**RE: VISUAL IMPACT ASSESSMENT - DA 10662 FOR SEPP 64 ADVERTISING SIGNAGE
PROPOSED AT HELP STREET, CHATSWOOD**

The purpose of this Addendum is to provide further detail to the visual impact assessment (VIA) prepared by Ethos Urban on behalf of Sydney Trains (the applicant) to support development application (DA) 10662 made to the NSW Department of Planning, Industry and Environment (DPIE).

Figure 1 Location of additional viewpoint at Help Street, Chatswood (Western Side)

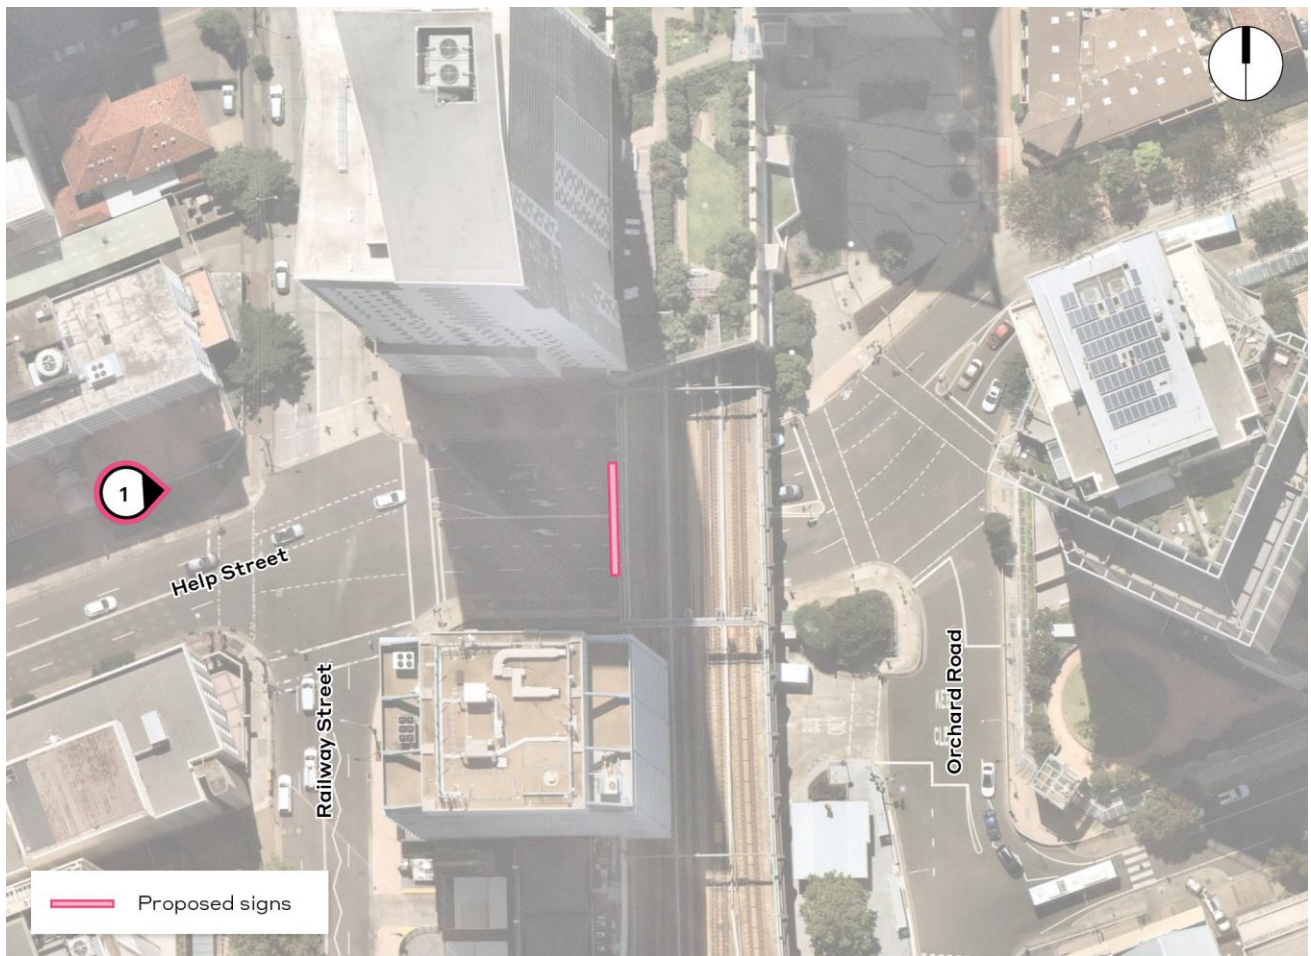
In light of the number of submissions received raising matters concerning visual impact, we understand DPIE have requested further analysis be undertaken on the Visual Impact Assessment (VIA).

An analysis has been prepared from one additional viewpoint from Help Street, on the western side of the rail corridor. The location of the additional viewpoint is illustrated in **Figure 1** and **Figure 2** shows the viewpoint to the proposed digital signage on the western elevation.
